SUBJECT: NuScale Power, LLC Response to NRC Request for Additional Information No. 523 (eRAI No. 9682) on the NuScale Design Certification Application

Response to Request for Additional Information Docket No. 52-048

eRAI No.: 9682

NRC Question No.: 12.03-66

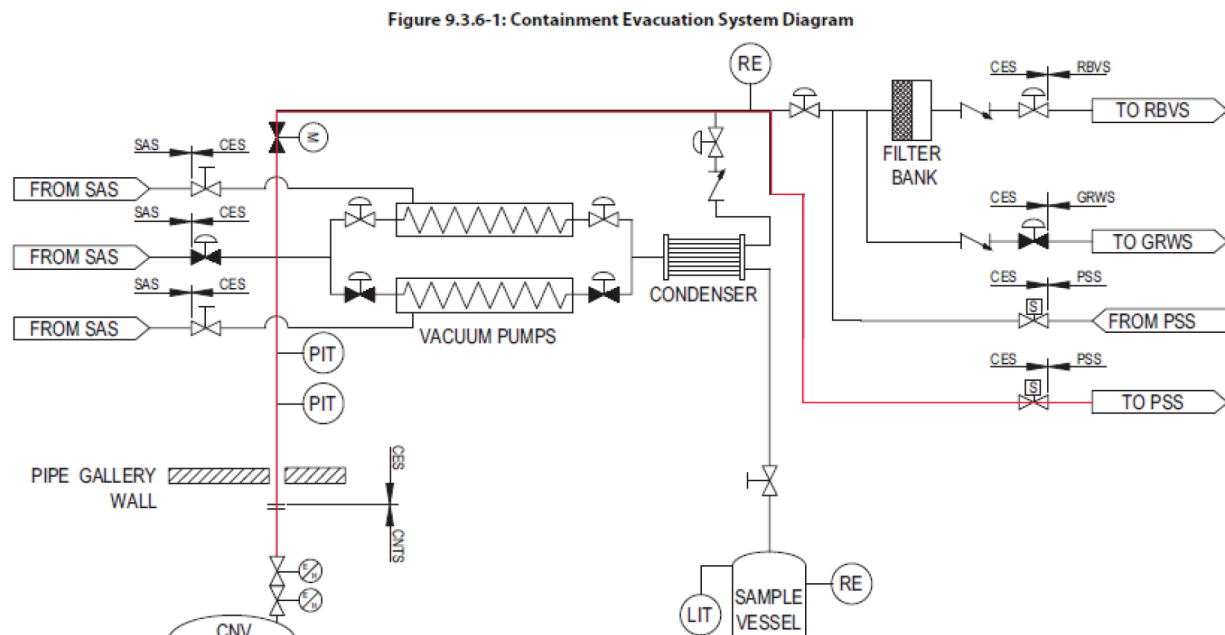
2. Provide, drawings which demonstrate the flow path, including equipment, which

would establish the continuous monitoring of hydrogen and oxygen in containment following a beyond design basis accident.

The flow path used to monitor for hydrogen includes portions of the CES, PSS and CFDS. These systems are depicted in FSAR Figures 9.3.6-1, 9.3.2-1, and 9.3.6-2, respectively. The flow path is shown below using red lines:
